GENVAC Aerospace Corporation
110 Alpha Park
Cleveland, OH 44143
January 17, 2019

SUBJECT: GENVAC AEROSPACE, REQUEST FOR ADDITIONAL INFORMATION
FOR A NEW EXEMPT DISTRIBUTION LICENSE

REF: Letter from Ms. Xu dated 18 December 2018

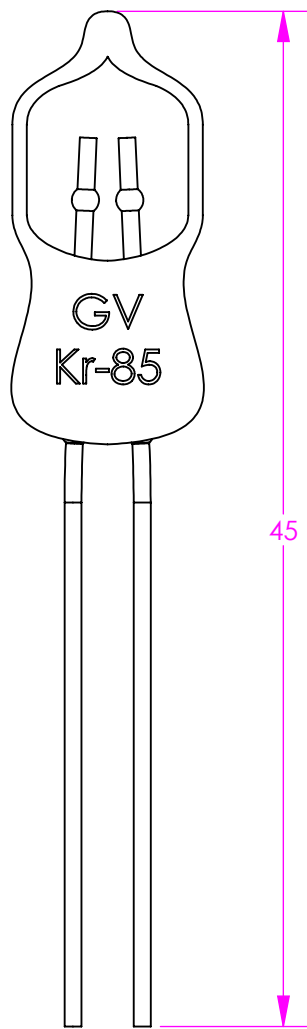
2. *“Provide the proposed method of labeling, or marking each unit, and its container with the identification of the manufacturer, or initial transferor, of the product and the byproduct material in the product.”*

A monogram is placed on each lamp, as pictured in attachment 1 and attachment 2. There is also a label on the outside of the lamp package, as shown in attachment 3. In attachment 4, we have included a larger copy of the monogram that appears on each lamp.
